PLANNING BOARD

To: Chair Brandon Mazer & Members of the Planning Board
From: Eric Freeman
Date: April 4, 2025
Re: 1584 Forest Avenue
Project ID: PL-003161-2024
CBL: 299 D027
Meeting Date: April 8, 2025

Acre Properties has submitted a Major Site Plan application for the construction of two three-story residential buildings, each containing 25 units, for a total of 50 residential units. The proposal includes 50 off-street, on-site parking spaces at 1584 Forest Avenue, located in the Residential RN-5 zone and B-1 Neighborhood Business zone.

Drawing No.
C101

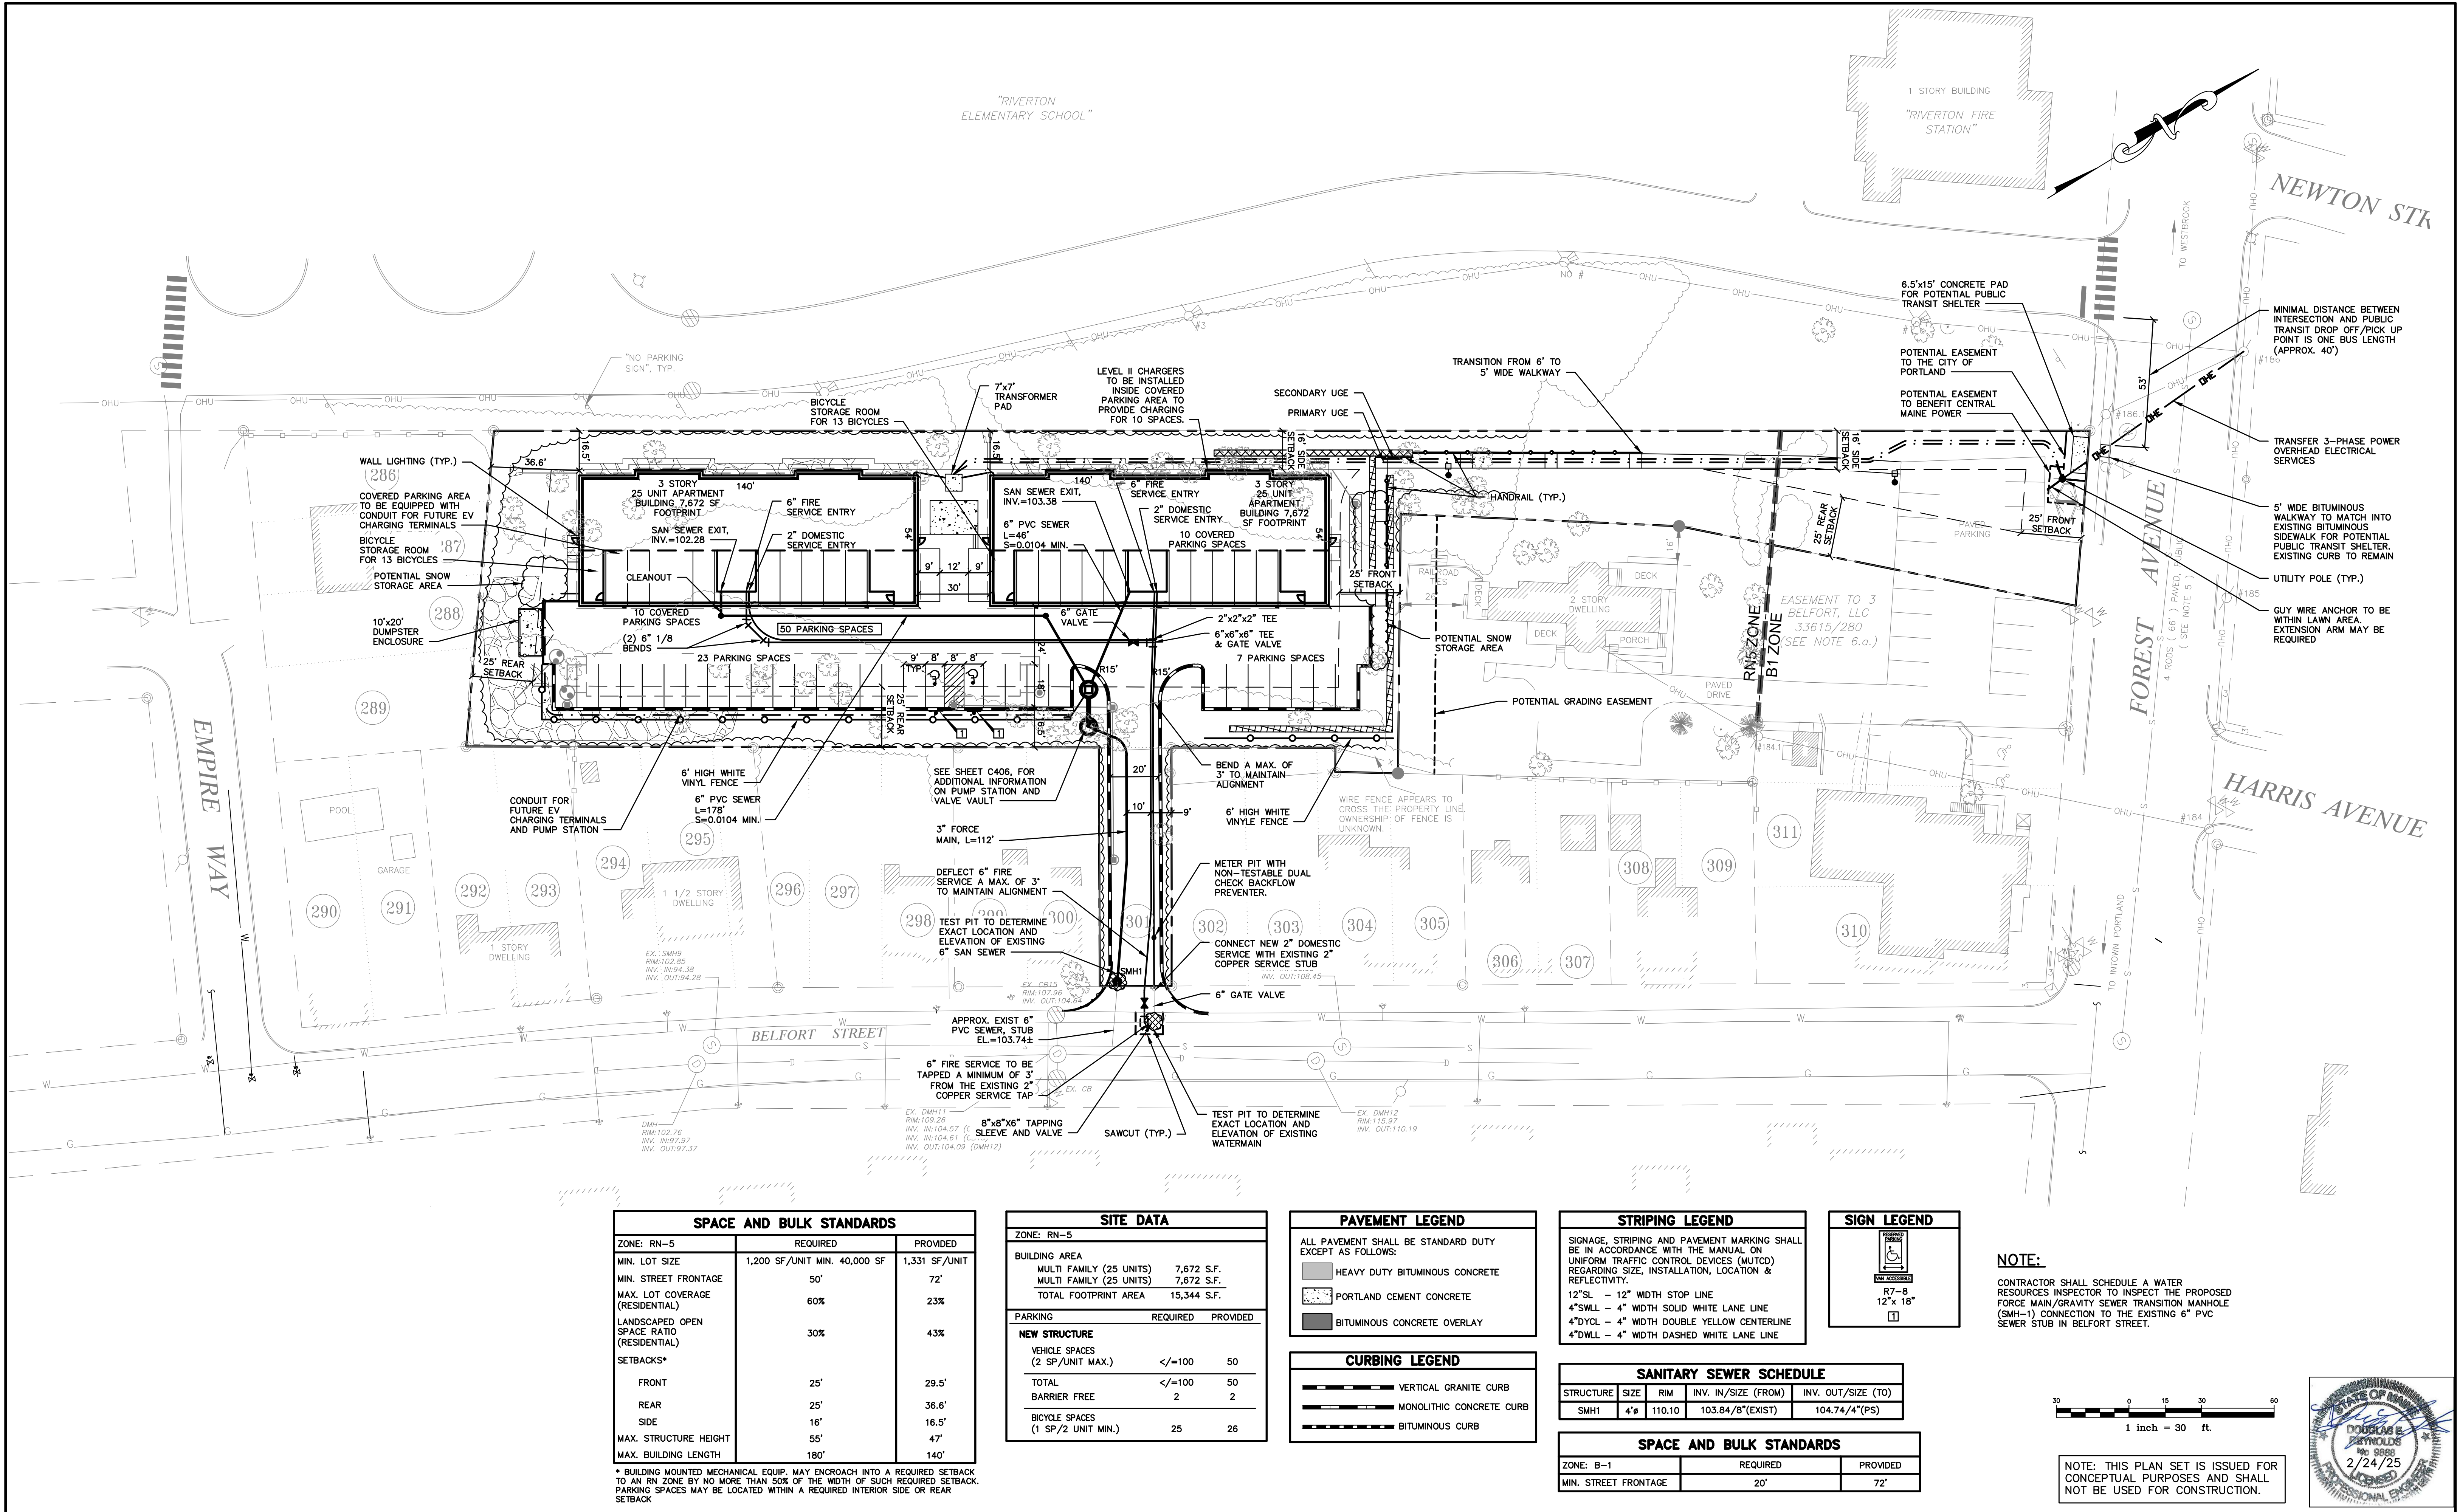
Response: The Site and Utility Plan (Sheet C101) has been revised to show catch basins and stormdrain piping (see revised plan set).

Response: This note has been added to Sheet C101, Site and Utility Plan (see revised plan set).

Response: As noted above, the subject parcel is considered a through-lot. The setbacks have been revised to reflect the appropriate requirements and do not affect the building location. Refer to the table below, as well as revised Sheet C101, Site and Utility Plan (see revised plan set).

Drawing No.
L100

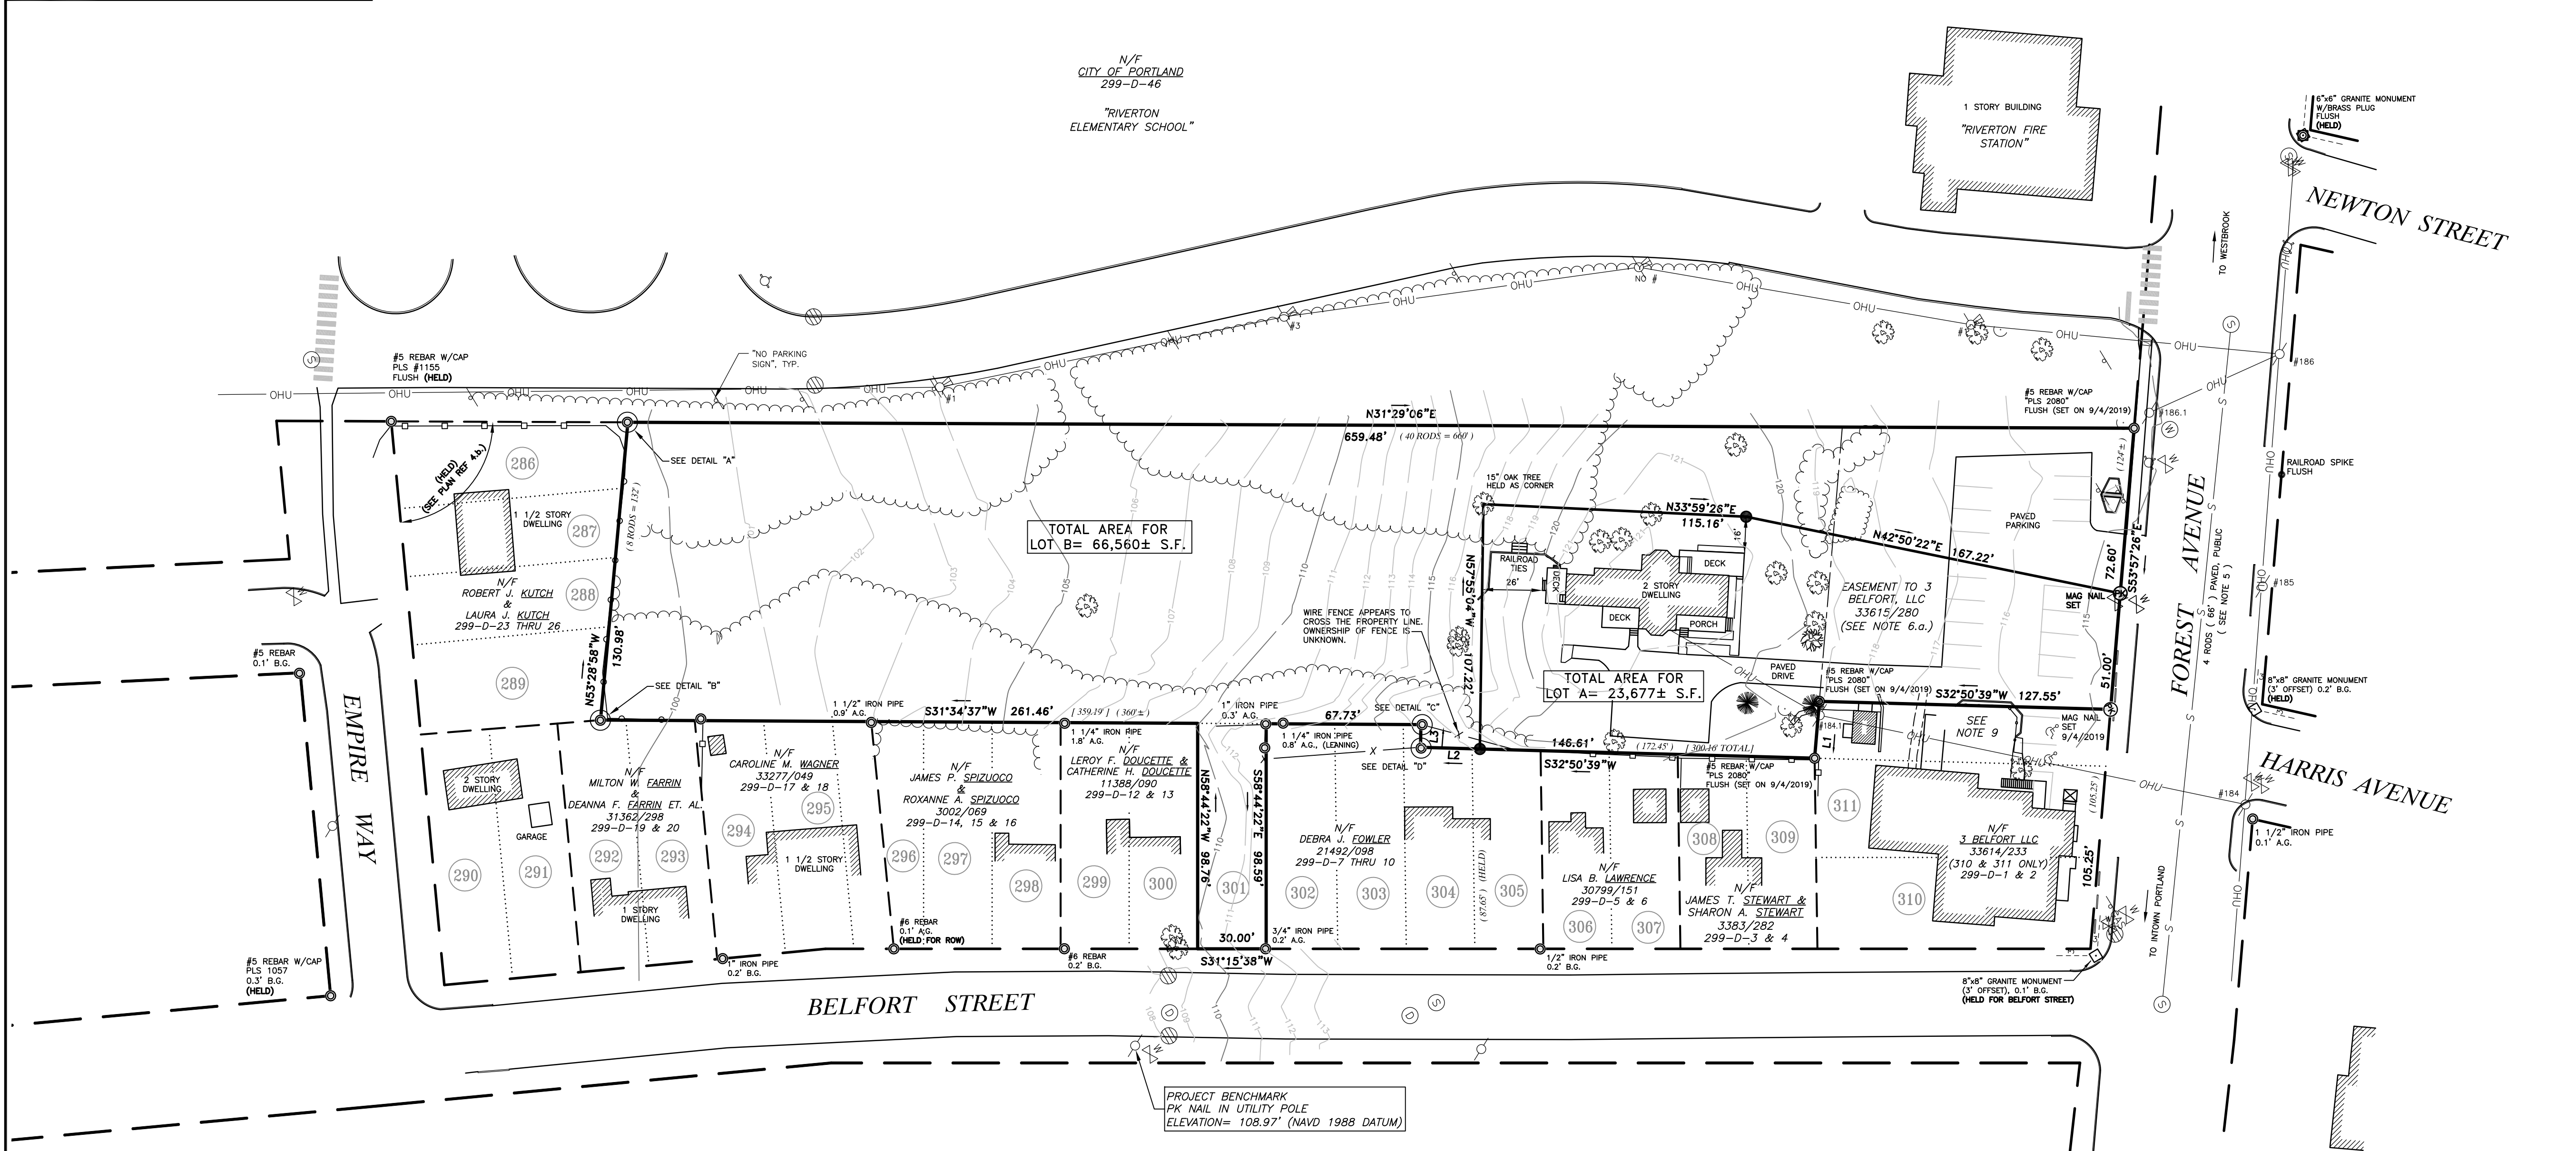
Response: As mentioned above, the rendering has been revised to reflect the existing tree line which will be preserved to the greatest extent practical. One tree, as shown on revised Sheet L100, was added to the westerly property line to supplement the existing buffering. Refer to the revised rendering included in Attachment 3 and the revised plan set for additional information.

ATTACHMENT 12
FIRE TRUCK TURNING FIGURE

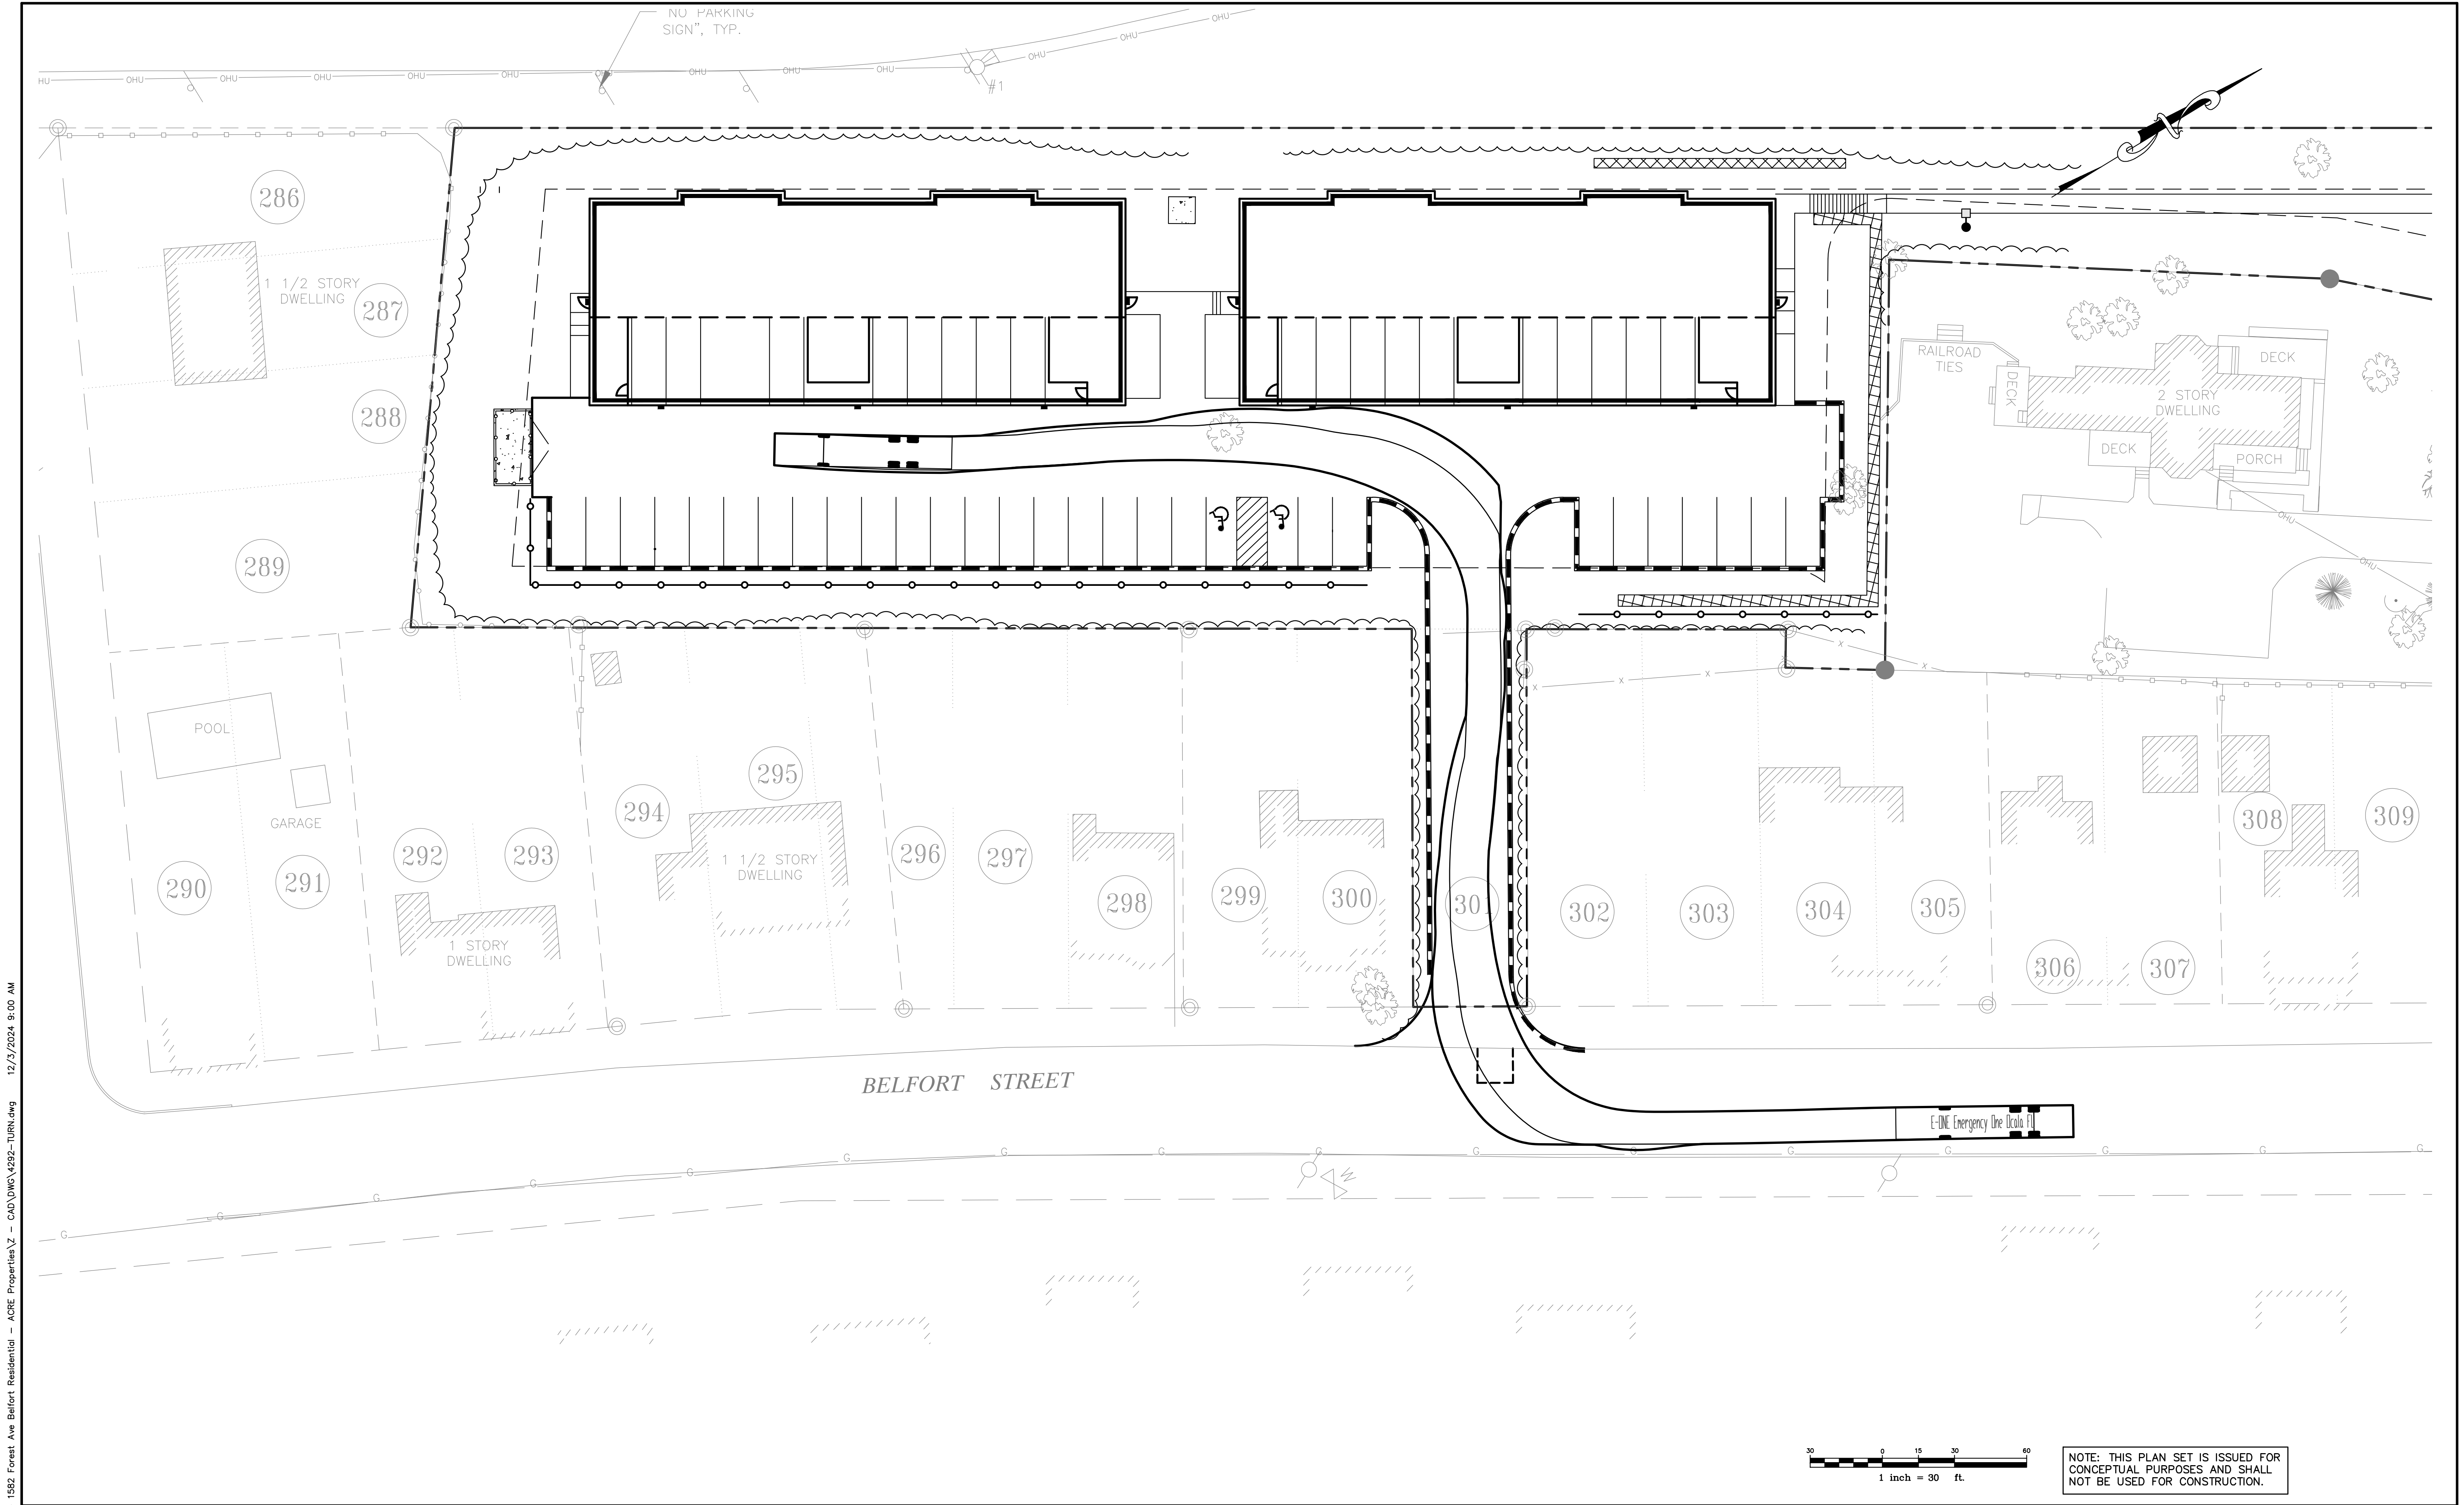
Response: The technical manual standard details for connection to Belfort Street have been reviewed. However, as shown on Sheet T1 included as Attachment 12 of the initial Major Site Plan Application submission, the curb radius was increased to allow for emergency vehicle access.

The primary site access point will be from Belfort Street. The site has been designed with a 20-foot wide access drive and 24-foot wide drive aisles that provide emergency vehicle access to both dwellings in the form of a hammerhead. Minimal reversing will be required to exit the site. A turning movement graphic, replicating a fire truck, is provided on Sheet T1 of the attached Plan Set.
